**City of Portland, Oregon**  
**Bureau of Development Services**  
**Land Use Services**  
 FROM CONCEPT TO CONSTRUCTION

**NOTICE OF A TYPE II DECISION ON A PROPOSAL IN YOUR NEIGHBORHOOD**

**CASE FILE NUMBER: LU 17-262782 DZ – FIELD OFFICE REVISIONS**

**Proposal:**  
 The applicant seeks Design Review approval for exterior alterations to a new commercial development for two new 6-story office buildings providing approximately 303,816 square feet to be located on a vacant 89,765 square foot site in the River District Subdistrict of the Central City Plan District. The development previously gained Land Use approval per LU 15-238635 DZM; alterations include the following:

# East Building | North Elevation (Front St)

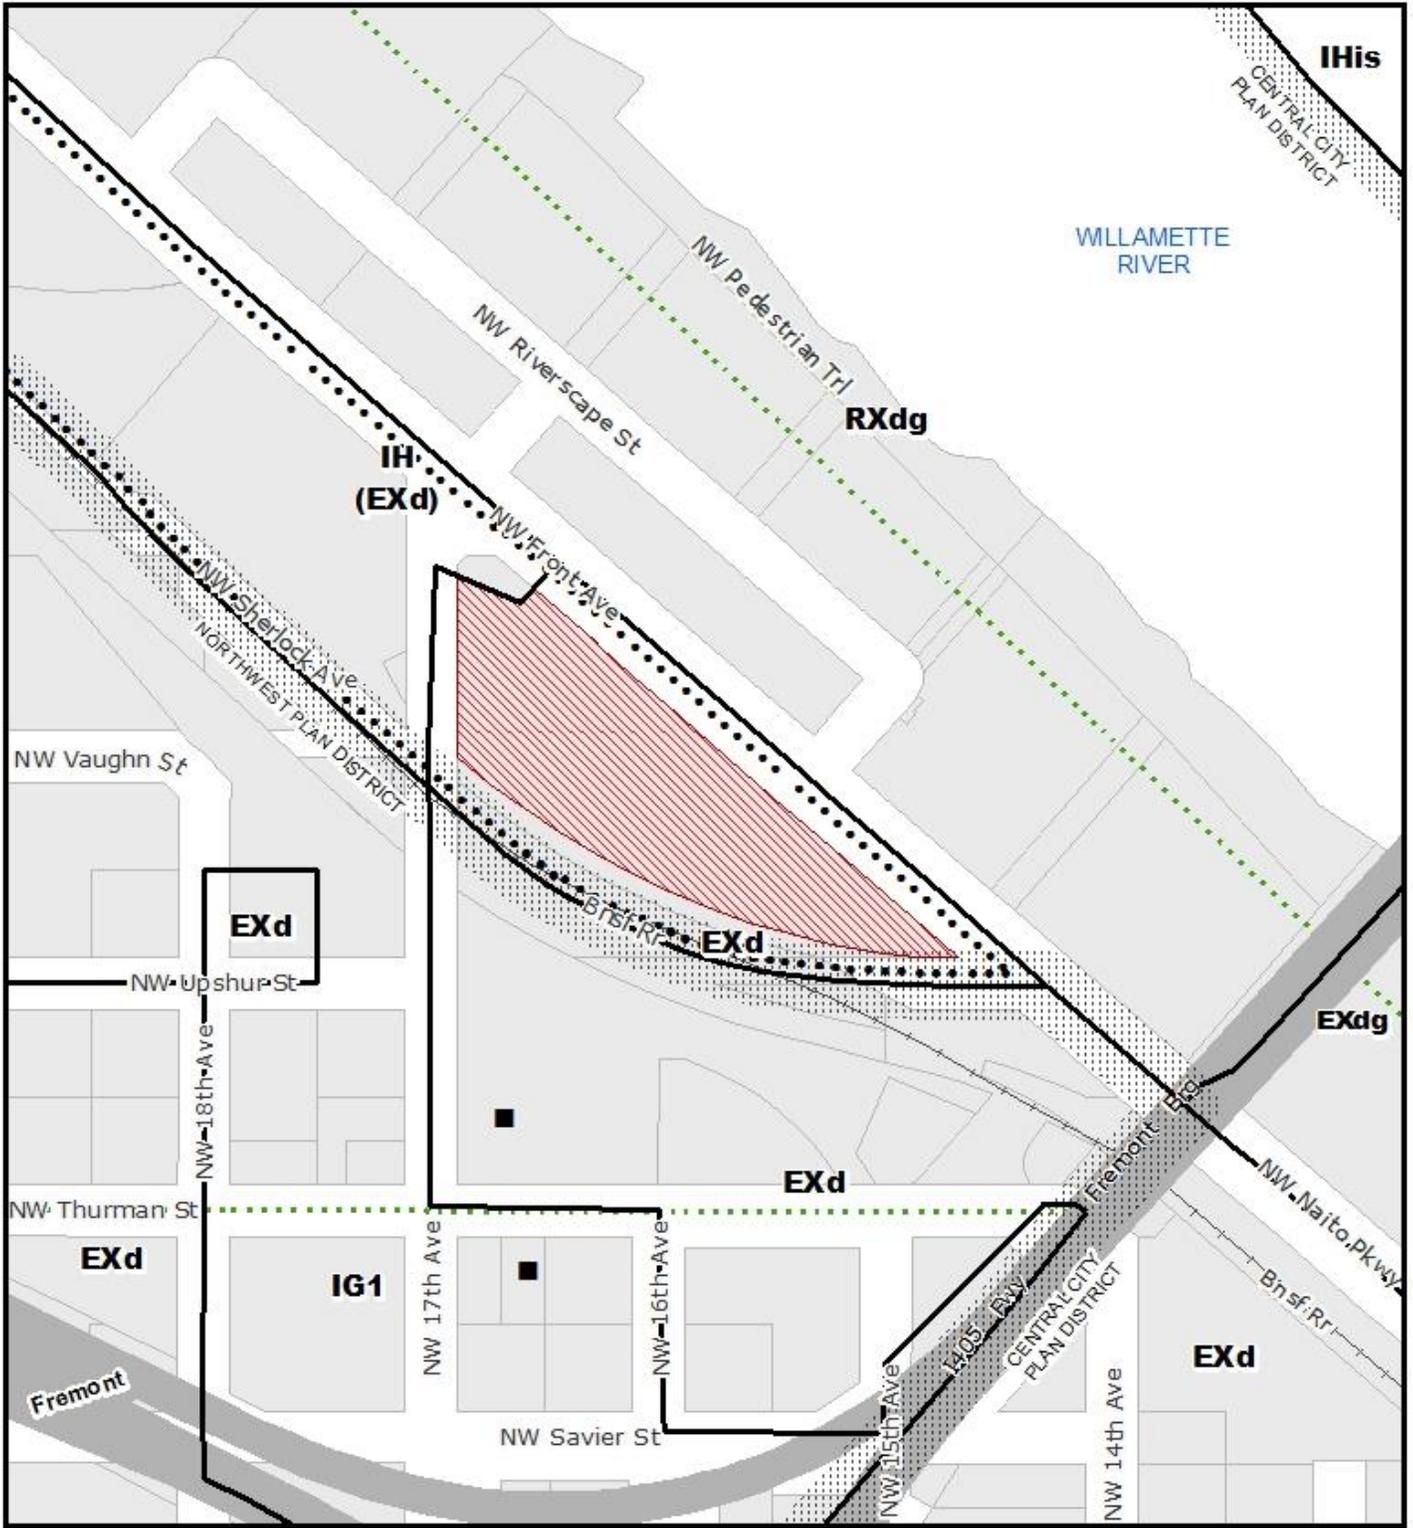
- ① Added PV Array System

Please note, the height of the PV Array System is lower than the height of the mechanical equipment.

- ② Composite Concrete Panel At Base
